Re: FortisBC Energy Inc. (FEI)

Application for Approval of a Certificate of Public Convenience and Necessity (CPCN) for the Okanagan Capacity Mitigation Project (OCMP) (Application)

Response to the BC Old Age Pensioners' Organization, Council of Senior Citizens' Organizations of BC, Active Support Against Poverty, Disability Alliance BC, Tenants Resource and Advisory Centre, and Together Against Poverty Society ("BCOAPO" or "BCOAPO et al.") Information Request (IR) No. 1

Figure 1: Updated Figure 3-1 with OCMP Total Additional Capacity

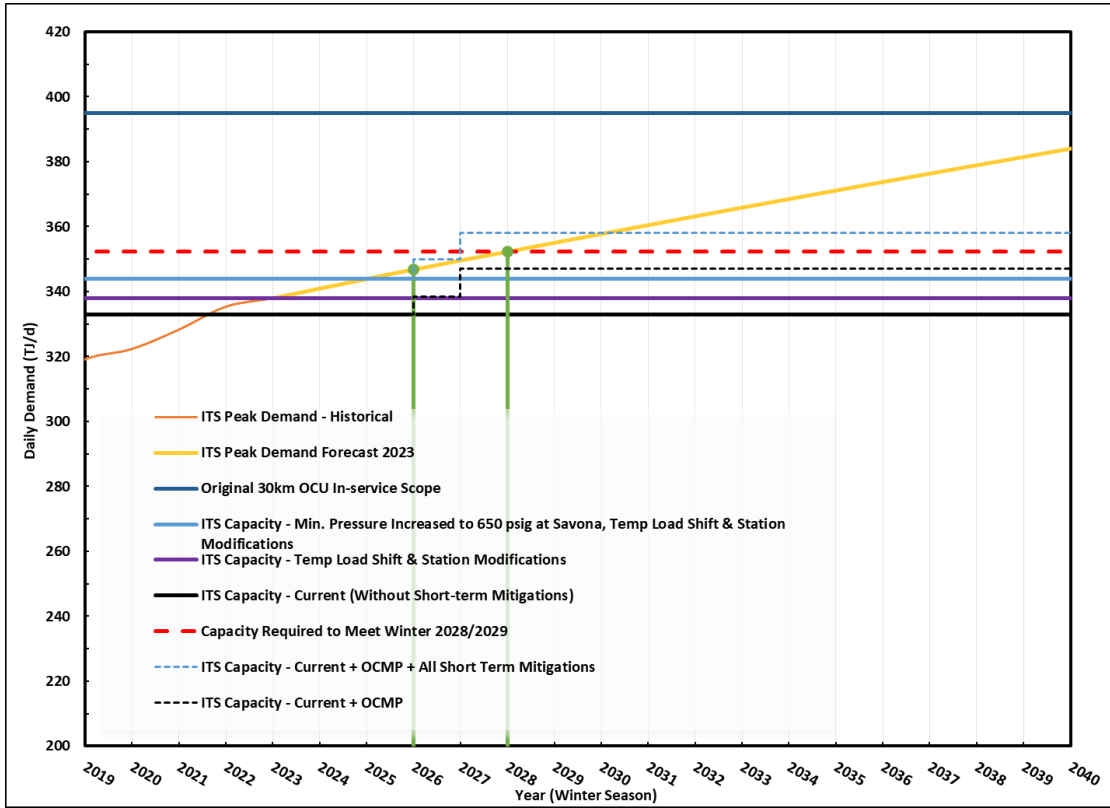
6 1.5 Please re-file a version of Figure 3-1 (Exhibit p. 11), 2023 Peak Demand Forecast,

7 adding lines with projections to 2040 reflecting: i) the total additional capacity

8 provided through the proposed Application; and ii) the total additional capacity

9 provided through the proposed Application as well as the short-term mitigation

10 measures as represented by the solid light blue line.

13 The figure below is an updated version of Figure 3-1 in the Application, including the total

14 additional capacity provided by the OCMP relative to the two solid lines: with short-term

15 mitigations (Light Blue) and without short-term mitigations (Black). These lines are also

16 characterized in the table below.

17 FEI notes that there are two step increases in the capacity lines in Figure 1 below that correspond

18 to the in-service timing of Phase 1 (2026) and Phase 2 (2027) of the OCMP. As explained in

19 Section 5.6.1 of the Application, for Phase 1 of the Project, FEI will be utilizing a mobile day tank

20 and three bulk LNG trailers for the winter of 2026/27; therefore, the capacity during this timeframe

21 was evaluated assuming a send out limitation of 3.5 MMcf/d. In 2027/28 and beyond, the capacity

22 is evaluated assuming Phase 2 of the Project is complete and assumes a send out limitation of

23 10.5 MMcf/d.

24 As shown in Figure 1, FEI is reliant on some degree of short-term mitigations to meet anticipated

25 peak demand both prior to and following the installation of the OCMP.

Figure 1: Alternate Version of Figure 3-1 with BCOAPO's Hypothetical Scenario that the Annual Peak Demand Forecast Growth Rate is Reduced by 1% from 2023 to 2040

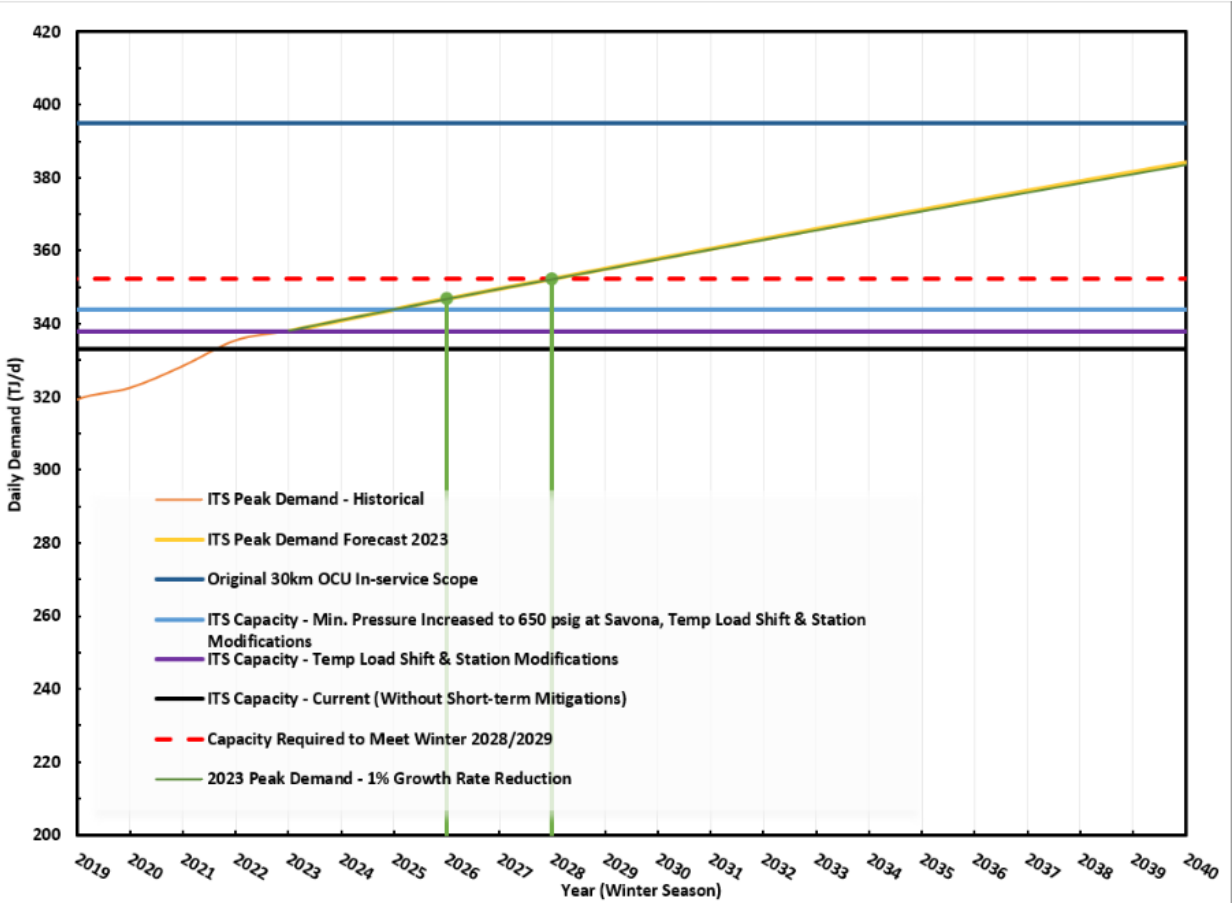
1.6 Please provide another version of Figure 3-1 that assumes the 2023 ITS Peak Demand Forecast (yellow line) growth rate is reduced by 1% over the forecast period 2023 – 2040. As part of the response, please provide a discussion of how

the reduced demand changes the evaluation metrics identified in 2.(i), 2.(ii) and 2.(iii) of the Application Requirements from the BCUC's 2015 Certificate of Public Convenience and Necessity Application Guidelines, specifically: the need for the project; the technical, economic, and financial feasibility of the project, whether the alternatives considered would change materially; and the revenue requirements of the project as well as the resulting impacts on customer rates.

The scenarios requested by BCOAPO in IR1 1.6, 1.7 and 1.8 are hypothetical and arbitrary. There is no supporting evidence to suggest that the growth rate of ITS peak demand or the total ITS peak demand will decline or remain flat from 2023 to 2029 (i.e., the time period with which the ITS capacity needs are being assessed and which the OCMP is being proposed to address). In fact, as shown in the response to BCUC IR1 1.1, customer attachments to the ITS continue to increase based on the 2023 year-end data when compared to the 2022 year-end data. FEI has determined the need for the OCMP based on the expected capacity shortfall in the Okanagan region by the winter of 2026/27 and has selected and scoped the preferred alternative based on the expected capacity needs up to and including the winter of 2028/29. FEI is not seeking approval of a project that will address further capacity needs beyond the winter of 2028/29 at this time; therefore, the peak demand forecast expectations and assumptions beyond the winter of 2028/29 modelled by Figure 3-1 of the Application or by BCOAPO's hypothetical scenarios have no impact on this Application.

However, in order to be responsive, please refer to Figures 1 to 3 below for the alternate versions of Figure 3-1 of the Application for each of the hypothetical scenarios suggested by BCOAPO. FEI notes that there would be no material difference between FEI's 2023 ITS peak demand forecast (yellow line in Figure 1 below) and BCOAPO's first hypothetical scenario, i.e., the annual growth rate is reduced by 1 percent each year (dark green line in Figure 1 below), thus there would be no change to the OCMP under this hypothetical scenario.

Figure 2: Alternate Version of Figure 3-1 with BCOAPO's Hypothetical Scenario that the Annual Peak Demand Forecast Remains Flat from 2023 to 2040

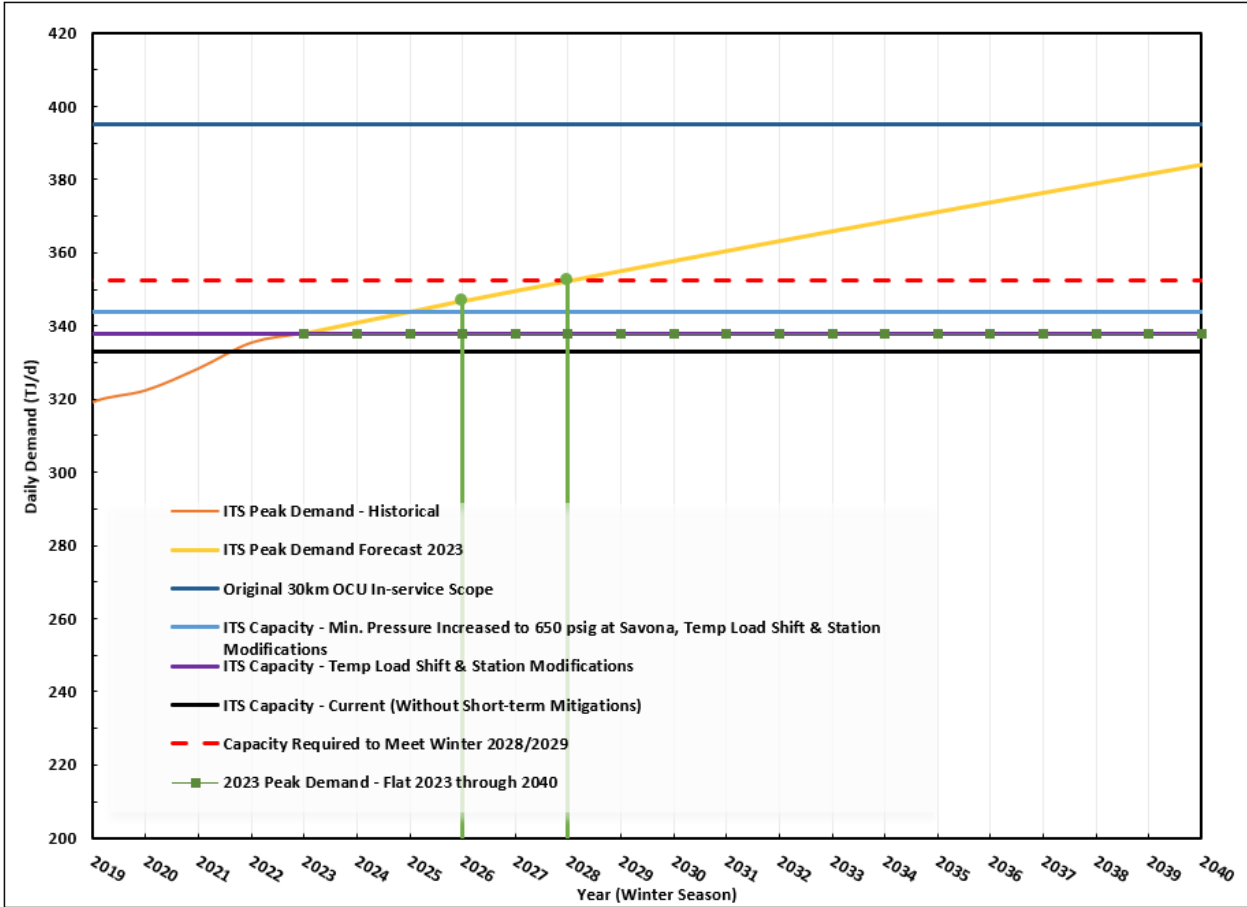
1.7 Please provide another version of Figure 3-1 that assumes the 2023 ITS Peak Demand Forecast (yellow line) is flat over the forecast period 2023 – 2040. As part of the response, please provide a discussion of how the reduced demand changes the OCMP feasibility. Please provide the material assumptions.

Please refer to the response to BCOAPO IR1 1.6.

Figure 3: Alternate Version of Figure 3-1 with BCOAPO's Hypothetical Scenario that the Peak Demand Forecast Declines 1% Each Year from 2023 to 2030 and Remains Flat Thereafter

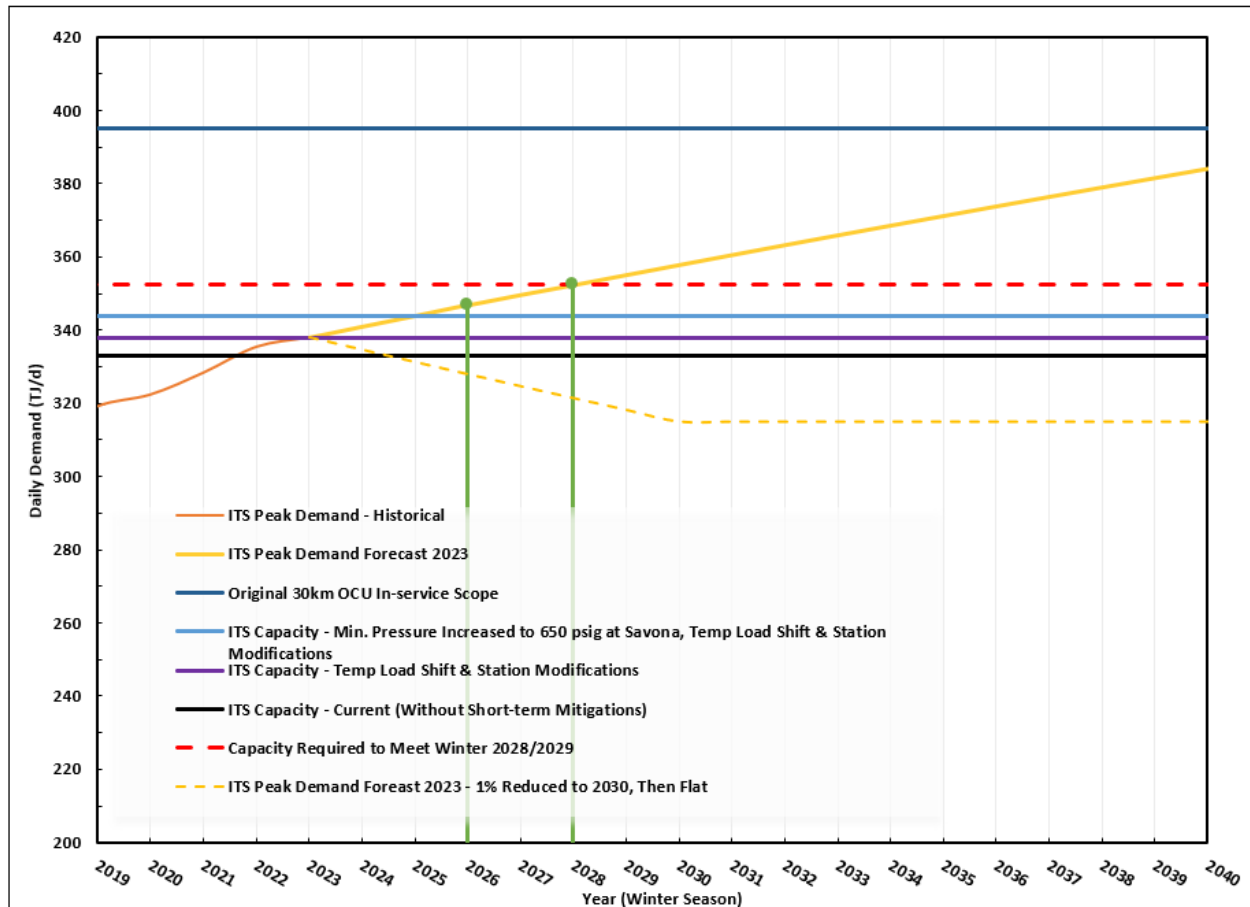
- 1 1.8 Please provide another version of Figure 3-1 that assumes the 2023 ITS Peak
2 Demand Forecast (yellow line) declines by 1% each year between 2023 – 2030
3 and is then flat over the remainder of the forecast period 2031 – 2040. As part of
4 the response, please provide a discussion of how the reduced demand changes
5 the OCMP feasibility. Please provide the material assumptions.

- 8 Please refer to the response to BCOAPO IR1 1.6.
